**BOARD OF COMMISSIONERS OF PUBLIC UTILITIES**

**REVIEW OF TWO GENERATION  
EXPANSION OPTIONS FOR THE  
LEAST-COST SUPPLY OF POWER TO  
ISLAND INTERCONNECTED CUSTOMERS  
FOR THE PERIOD 2011 – 2067**

**REPORT TO GOVERNMENT**

**MARCH 30, 2012**

### Preliminary HVdc Link Expansion Plan vs. Load Forecast

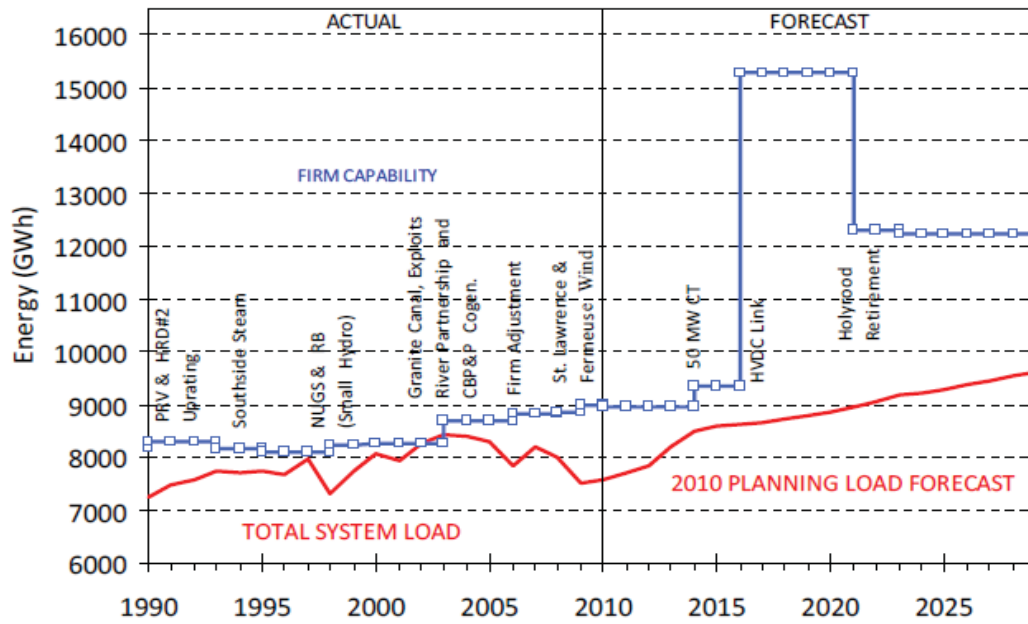
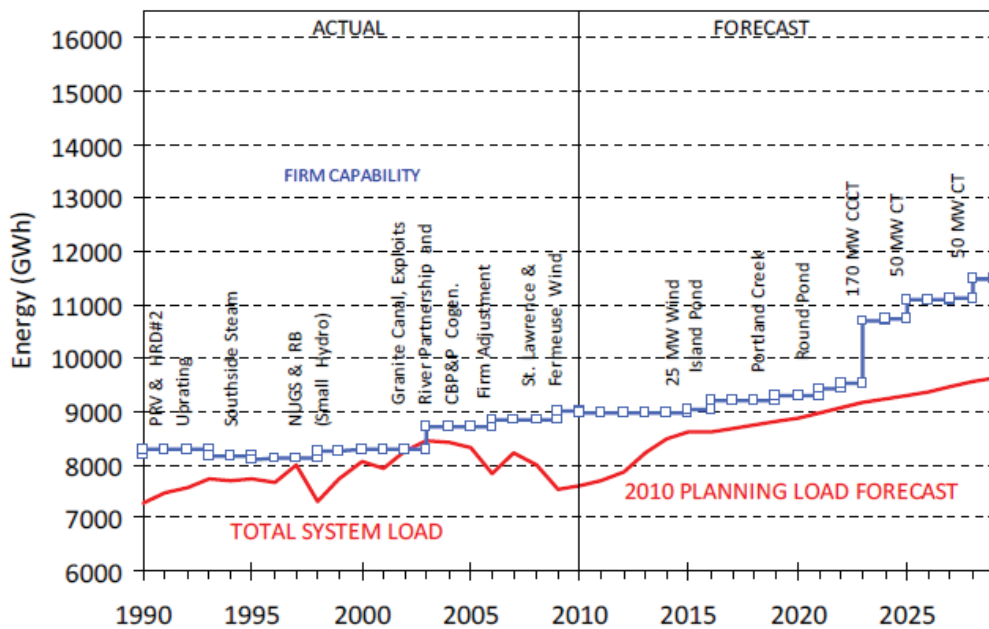
In relation to how the 2010 Planning Load Forecast relates to system capability, the Board refers to the comparison graphs of forecasted load and system capability set out above. The first graph shows the forecast energy shortfall in 2021. The next two graphs show how the two options will meet the forecast load. The Interconnected Option involves a very large incremental increase in generation capability and a significant amount of excess energy and capacity until well beyond the 20-year planning period. This graph highlights the significance of the assumption required by the Terms of Reference that the excess power is not monetized or utilized. As shown in the third graph the Isolated Island Option offers what might be considered a less risky approach more in line with principles of distributed generation, where capacity and energy are added in smaller increments more closely matching the load forecast.

These graphs show that there is not an immediate need for the large incremental supply associated with the Interconnected Option and that Island electricity needs could be met in the short to medium term with available renewable sources on the Island and/or additional thermal generation. It appears that avoidance of fuel costs is a critical factor in this generation planning decision. Nalcor's analysis shows that the Interconnected Option is least-cost primarily as a result of the avoided fuel costs associated with the closure of the Holyrood Thermal Generating Station.
